## ***Scope and Timetable for consultant Sound analysis - impacts of MMC relocation of the heliport***

### **INTRODUCTION**

**Graphic A: Submitted Aerial showing original (2004) Study points and the approx. location of the existing and proposed helipads**

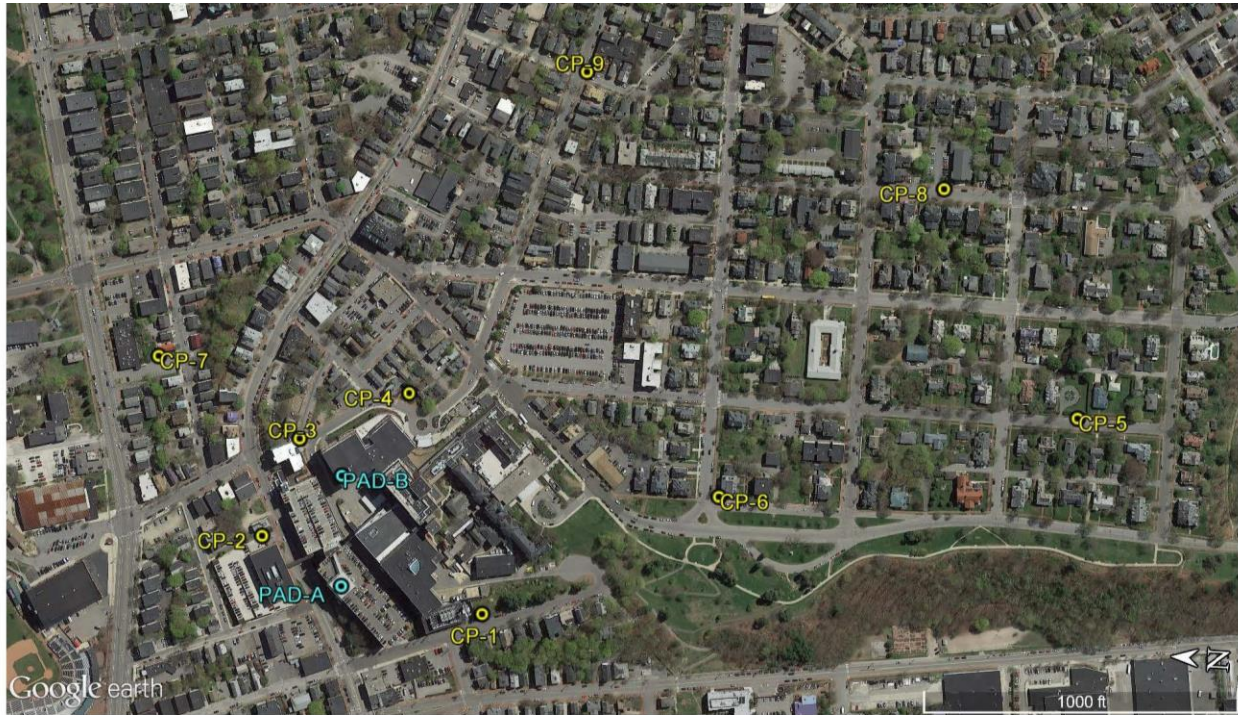
- b. The concern is that the submitted comparative information (see Graphic B at end of this note) used the same study points as for the original studies carried out at the time the current location was chosen (for which HMMH was the review consultant for the Planning Division). The new location is moved to the north and east and therefore is nearer (albeit higher) to residential and other properties on that side of the main MMC complex (see Graphic A at end of this note).

3. MMC was requested (in e-mail to MMC as quoted below) to include the following elements in the Plan:
  - a. The identification of several additional study points to reflect the fact that the new helipad location will not benefit from the shadow of any MMC or other building (documents from the 2004/5 review confirm that it was assumed by both MMC and City sound consultants that sound from the helipad at its existing location would be "blocked" by buildings to the north of it). The new location could affect residents and businesses that are not impacted by the existing helipad. The plan below (from your submitted report) shows the original study locations for the submitted sound study and there are no points to the mid north and to the NE of the proposed helipad location.
